Request Summary

- Final Development Plan, Design Review, and Conditional Use for a Sheetz gas station and quick service restaurant
 - Zoned CC – Community Commercial
 - Gasoline service station is a conditional use
 - Currently 4.63-acre site, layout planned for future 1.25-acre lot split
 - Proposed 4,959 SF restaurant/retail building with no drive thru
 - Exterior is brick and masonry veneer and red/dark bronze metal roof
 - Fuel pump canopy to match building
 - All parking is located to front and side of building; fuel pumps to front
 - 27 parking spaces required; 35 proposed

Land Use Plan

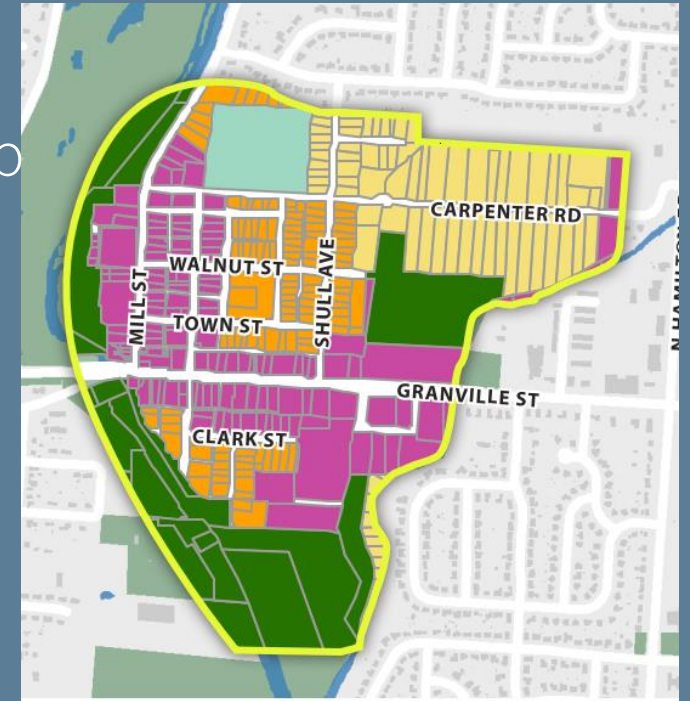
- Site is designated as “Mixed Use” on FLUM:
 - Higher density, urban/semi-urban development with buildings towards street and parking to the rear
 - Recommended uses are retail, office, and residential
- Also part of “downtown” focus area:
 - Medium to high density residential or mixed use
 - Development oriented towards street
 - Expand downtown onto Granville Street
 - Human-scale development with emphasis on pedestrian
 - Expand non-motorized network
 - Mix of uses to attract businesses and residential development that support downtown residents
